**RESOLUTION  
TOWNSHIP OF NEPTUNE  
HISTORIC PRESERVATION COMMISSION  
RESOLUTION OF MEMORIALIZATION  
MONMOUTH COUNTY, NEW JERSEY  
DENIAL OF NEW CONSTRUCTION**

**IN THE MATTER OF: OG NORTH END REDEVELOPMENT, LLC  
(Lake Ave Walkway, 17 Spray Ave, and Boardwalk North End)  
APPLICATION NO.: HPC2020-0063**

Applicant’s Exhibits A-1 through A-12, inclusive.  
HPC Tech Review Report (“Tech Review Report”),  
appended hereto as Appendix A.

Illustration B.11. — East elevation of proposed pediment-topped entry to courtyard corridor (Sheet A-5).

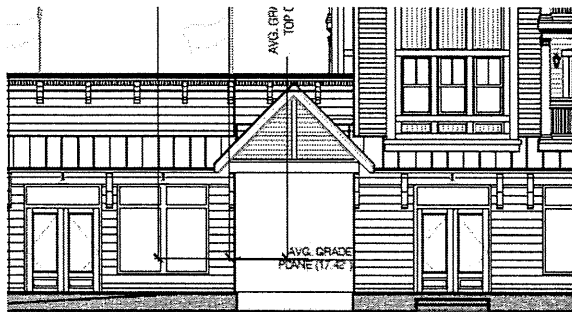
**B.11. — Courtyard Corridor:** At Tech’s request, OGNED agreed to reconsider the access corridor that leads from the boardwalk to the interior courtyard, to better highlight the access point and make it look more like a feature of the Retail frontage and less like an alley. At present, the pedimented entry has little relationship to the rest of the Retail area or the boardwalk itself. Tech asked OGNED to consider ways to extend that entrance forward (as a pergola or other structure extending toward the boardwalk) to better invite pedestrians into the space. The Plan presented did not activate courtyard access in any way, provided no shade, and seemed “uninviting.” No change to this area is reflected in the current Plan. NOTE: 3 June 2022 Summary of Changes: *Windows provided in the retail spaces on both sides of the corridor passageway.*

**B.12. — Courtyard Corridor:** Is the entrance to the courtyard at grade (at boardwalk level) or raised to the level of the sidewalk that runs in front of the Retail? If at grade, what accommodations are made to access the courtyard entrance from the raised sidewalk? Also, will the handicap accessible ramp necessitate closing off the sidewalk with a railing where it meets the corridor entrance? (See Illustration B.11., above.)

Illustration C.5.a. — West roof elevation of the Hotel (Sheet A-12).

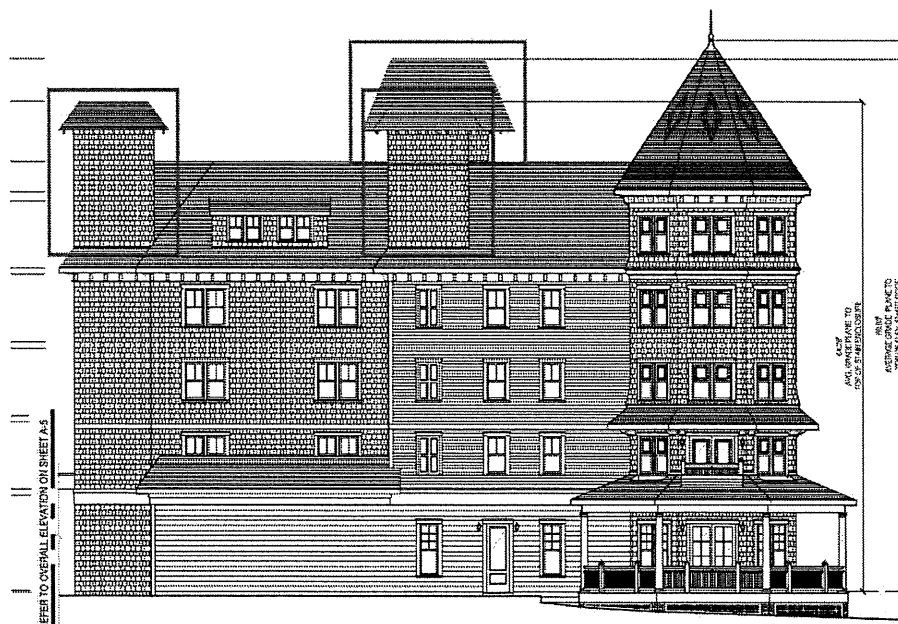
C.5. — **Hotel: Roof Projections.** Two staircase towers also serve the non-conforming roof decks and present similar design non-conformities as a result.

Illustration C.5.b. — North roof elevation of the Hotel (Sheet A-12).

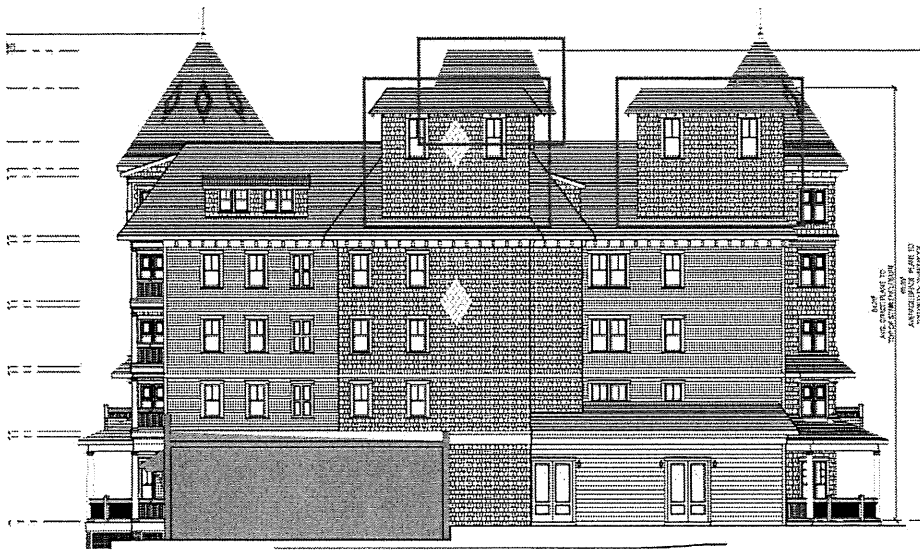
**C.6. — Hotel: Roof Projections.** The elevator and staircase projections were called out by Tech as non-conforming early in the review process. At Tech’s request, OGNED attempted to turn these non-conformities into architectural focal points by topping them with roof forms. However, Tech feels the design of these auxiliary roof forms are unsuccessful in that they diminish and confuse the Queen Anne aesthetic rather than enhance it. The current roof forms on the stairways and elevator where they extend above the parapet look like a collection of huts.

Illustration C.8.a. — Hotel dormers, south elevation, showing two sets of double doors beneath gable roofs and two sets of double doors beneath shed roofs (Sheet A-11).

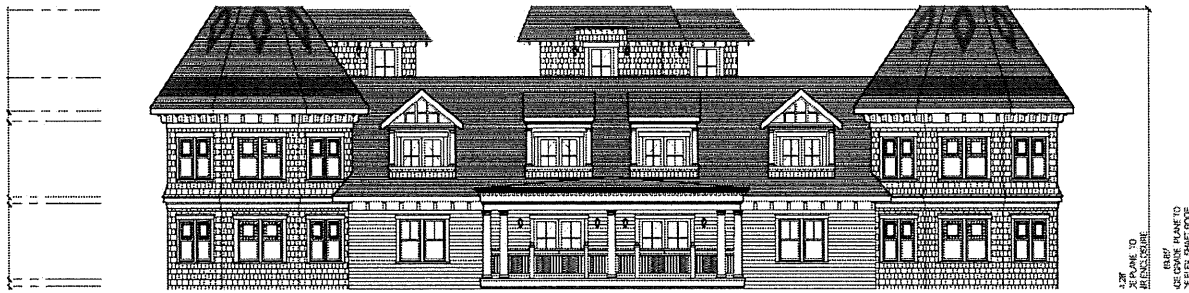
C.8. — **Hotel: Dormers.** OGNED presented designs with individual dormers, double (or paired) dormers, gabled dormers, shed dormers, and combinations of all four. Tech questioned whether mixing of dormer styles—shed and gable—magnified the weakness of secondary elements such as the proposed horizontal roofs on the elevator shaft and stairway towers. Tech suggested gable dormers would better re-enforce the verticality of primary elements such as the corner tower roofs, and be more in keeping with the Queen Anne style. NOTE: 3 June 2022 Summary of Changes: *Revised detailing at roof-top dormers. Half-size columns removed and replaced with large brackets. Dormer roof changed from shed to gable to accommodate the revised detailing. Dormer width enlarged to accommodate (1) wall lantern on each side of the doors.*

Illustration C.8.c. — Hotel dormers, north elevation, showing two sets of double windows beneath a shed roof (Sheet A-12).

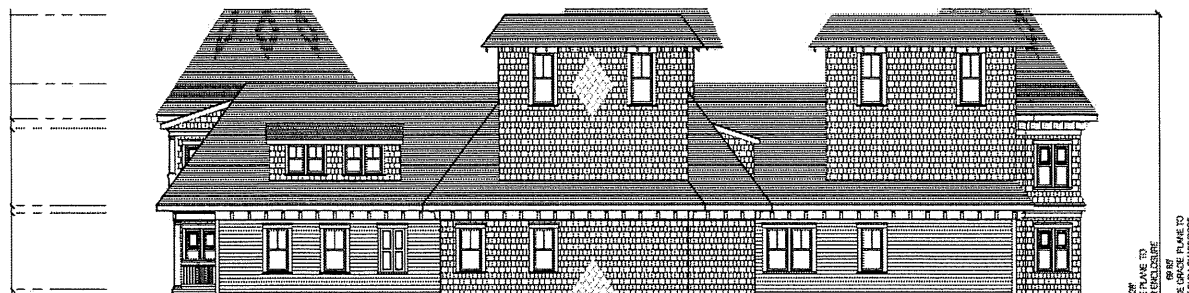
C.11. — **Hotel: Dormers.** The double dormers on the north and west should be changed to conforming individual dormers. Also, these dormers appear smaller than those at the south and east, perhaps due to them containing only windows and not doors. Please clarify.

Illustration C.10.c. — East elevation of Hotel tower, second floor, showing corbels suggested for use in dormers (Sheet A-11).

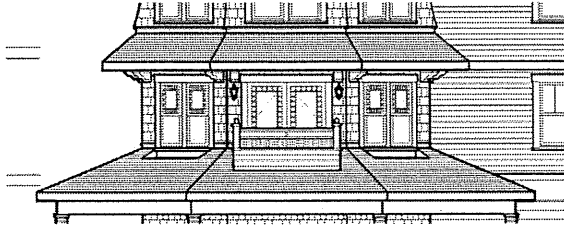
C.9. — **Hotel: Dormers.** The inclusion of paneling in the dormer gables at the south and east is historically inappropriate. Examples exist of doweled screens and orthogonal lattice in gables, but paneling of this sort is not appropriate.

Illustration D.4. — East elevation of Condominium Building One (Sheet A-5) showing single balcony doors with non-conforming single side-light windows on each of the six balconies. These balcony doors should match single balcony doors on other elevations and should not include side-light windows.

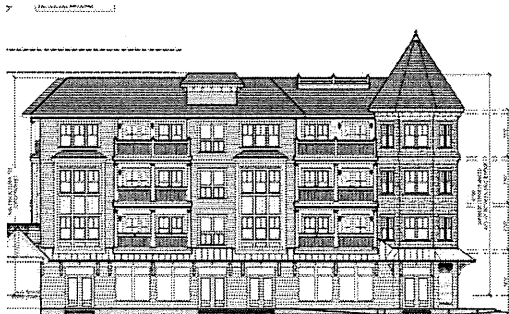
**D.4. — Condominiums:** The east elevation of Building One show single balcony doors flanked by single sidelight windows. Single sidelight windows are inappropriate. These doors should match the single doors found elsewhere on Building One and Building Two. *NOTE: 3 June 2022 Summary of Changes: Sidelights removed on porches/balconies. Single french door centered in each bay with a single light fixture located on the latch side of the door.*

Illustration E.5. — North elevation of Hotel (Sheet A-12), showing upper staircase towers with two windows each.

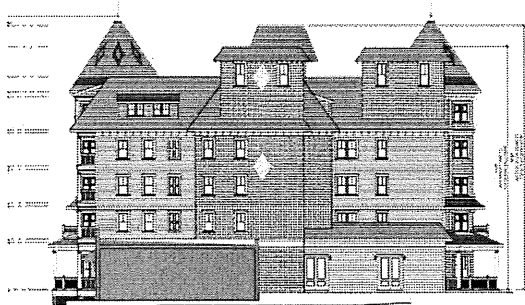
E.5. — **Hotel:** The fifth-floor stair tower, north elevation, should have a third window (or shuttered window) in order to maintain the rhythm of the fenestration.

Illustration E.10. — West elevation of Condominium Building Two (Sheet A-8).

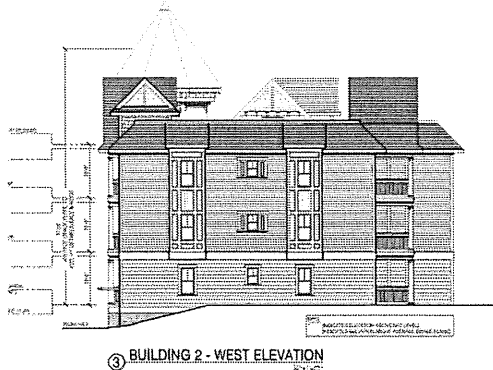
E.10. — **Condominiums:** Tech found the west elevation of Building Two particularly unsuccessful with two floating projections hanging down from shed roofs. These projections end abruptly above single windows at the first story. The projections include single windows on each floor (with the rest of the projection covered in vertical-paneled frames). Single windows on projections of this type are non-historic. In the center of the west elevation are three under-sized windows: one with traditional trim, the other two flanked by more panels and extended crowns. The west elevation will be prominent not only to residents in properties to the west of the development and pedestrians walking along Wesley Lake, but also to traffic traveling east down

Lake Avenue on the Asbury side of Wesley Lake. Tech considers this elevation under-designed, un-historic, and in need of redesign.

Illustration F.4. — North elevation of the Hotel showing over-sized diamond patterns in shingled cladding. (Sheet A-12).

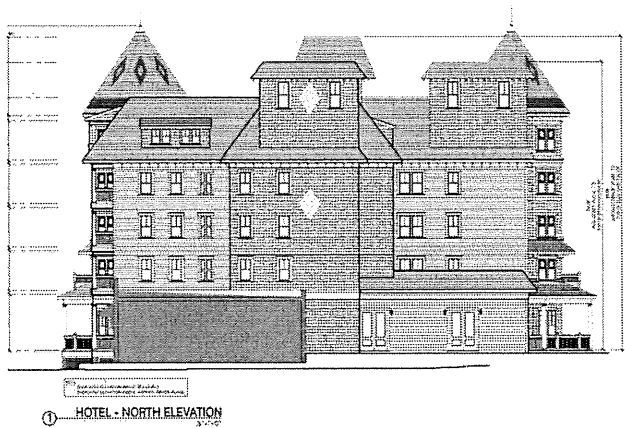
F.4. — **Hotel: Siding.** At the north elevation two “diamond” details are indicated in the proposed shakes. The size of the diamonds is excessive and the location awkward: in the fifth story staircase tower the diamond appears crowded and crammed near the roofline; on the blank wall further down the tower, the diamond is oddly aligned and oversized. Both diamonds should be eliminated or reconsidered in more historic scale and placement. NOTE: 3 June 2022 Summary of Changes: *North Elevation: Reduced the size of the diamond shingle pattern by 20%.*

Illustration G.4.a. — Second floor plan of Condominium Building One showing hybrid inset balconies at all four elevations (Sheet A-2).

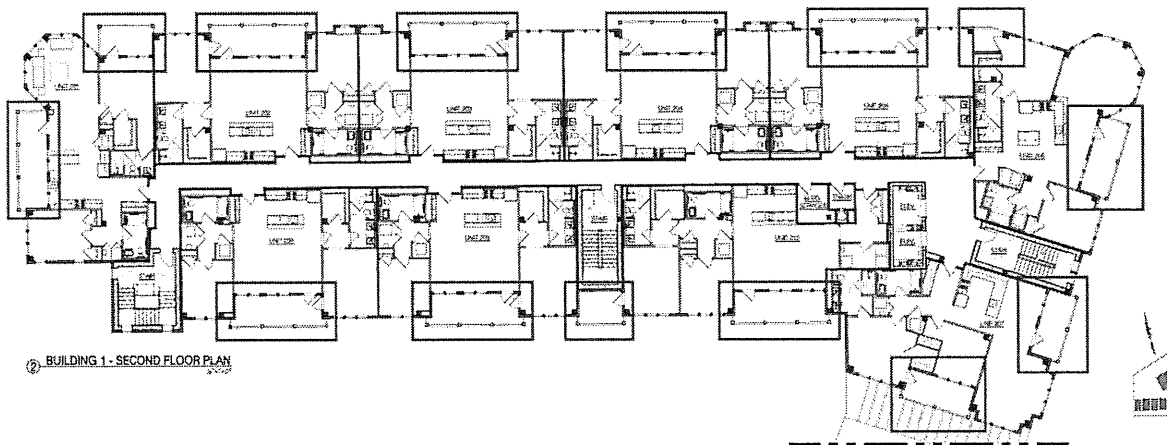
G.4. — Township of Neptune, Land Development Ordinance §508 “Historic Preservation Guidelines, D, 12, “Exterior Features. A structure’s related exterior features such as but are not limited to lighting fixtures, fences, signs, sidewalks, windows, doors, shutters, siding, gutters, balustrades, railings, columns, cornices, moldings, trim, stairs, steps, porches, walks, patios, driveways and parking areas shall be compatible with the features of those structures to which it is visually related and shall be appropriate for the historic period for which the structure is significant.”

Illustrations G.5.a. and G.5.b. — Detail of northeast corner of Condominium Building One showing windowless mini-balconies above the north building access door (Sheet A-6). These balconies are circle in the second-floor plan, at right (Sheet A-2).

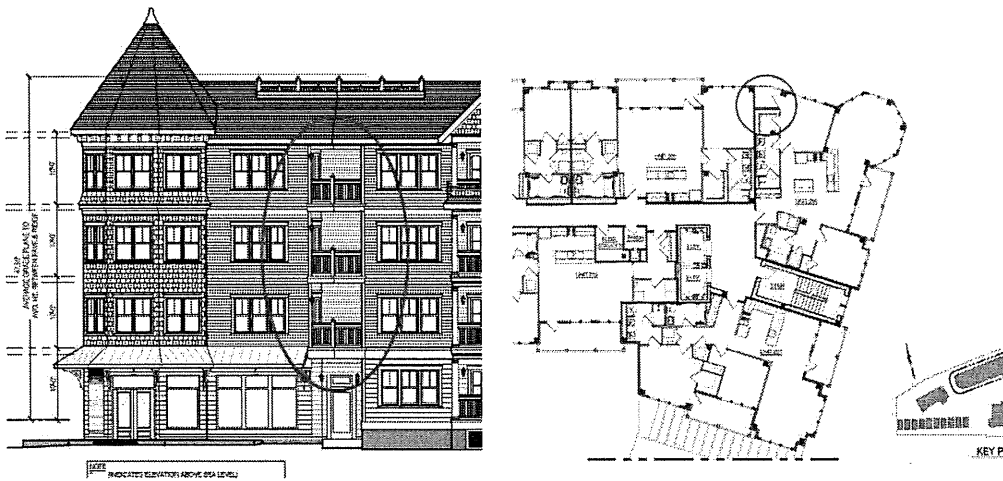
G.5. — **Condominiums:** At the north elevation, just west of the Building One tower, above the north access door, are a row of inset-balconies. These balconies occur at the point where the building jogs southwest along Wesley Lake. These balconies are five-sided, due to a bend in their railings, have no windows, single doors, and no lighting. They are non-historic in character, awkward in size and placement, and differ in every way from any other balcony in the project. Tech recommends they be reconsidered or eliminated. NOTE: 3 June 2022 Summary of Changes: *Shutters added at inset balcony on the North East corner.*

Illustration H.6. — Plan showing proposed Condominium Building One roof path and roof deck (Sheet A-4).

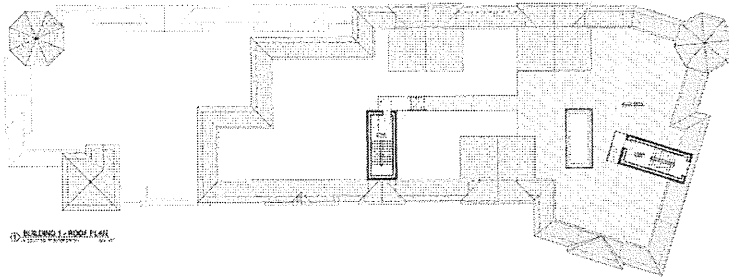
H.8. — **Condominiums:** Are railings proposed for the rooftop pathway and roof deck of Condominium Building One? Please provide cat/cut for review.

Illustration I.8.a. — North elevation of Condominium Building One showing lighting (most of which entails two light fixtures flanking single doors onto balconies) (Sheet A-6).

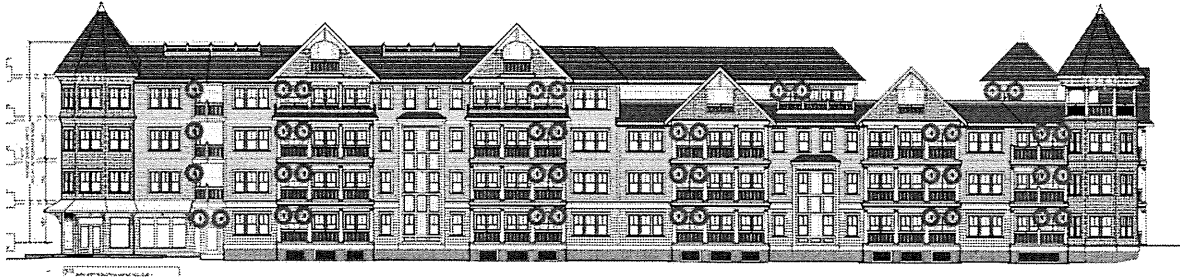
I.8. — **Condominiums:** Elevations show single doors out to balconies with lighting fixtures on each side of the door. Balconies have multiple windows from which light is reasonably expected to pour out into the balcony areas. Fixtures on the both the opening-side and the hinge-side of single doors is considered excessive. NOTE: 3 June 2022 Summary of Changes: *Provided a*

*single light fixture located on the latch side of all porch/balcony doors.*

Illustration N.1.a. — Proposed coverage of Hotel Roof deck (emphasis added) (Sheet A-10).

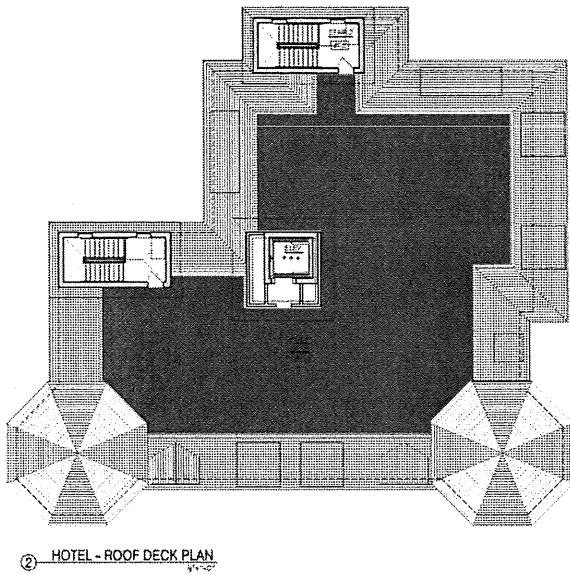
N.1. — **Roof Decks.** The Hotel & Condominium Building One each have large-scale, public roof decks. Condominium Building Two has three private roof decks. Roof decks are non-conforming with the Guidelines. The roof decks proposed are visible in so far as railings and balusters along the parapet provide “viewing platforms” (some beneath the proposed faux-gables). These breaks in the parapet reveal the presence of the roof decks. There is a reasonable expectation that appurtenances related to roof decks (umbrellas, tents, pergolas, rooftop plantings, lighting, etc.) will further reveal the presence of these roof decks atop these buildings. (See, Guidelines, page 27, Section N, “Roof top construction featuring sun decks, swimming pools, and hot tubs are not in keeping with the designs of the Victorian Era nor other historic styles of architecture within the Ocean Grove Historic District. Therefore, such features will be viewed contrary to the “Spirit” of the architectural setting. Introduction of any such feature must fully demonstrate that such a feature would be designed so as not to be visible to public view...”)
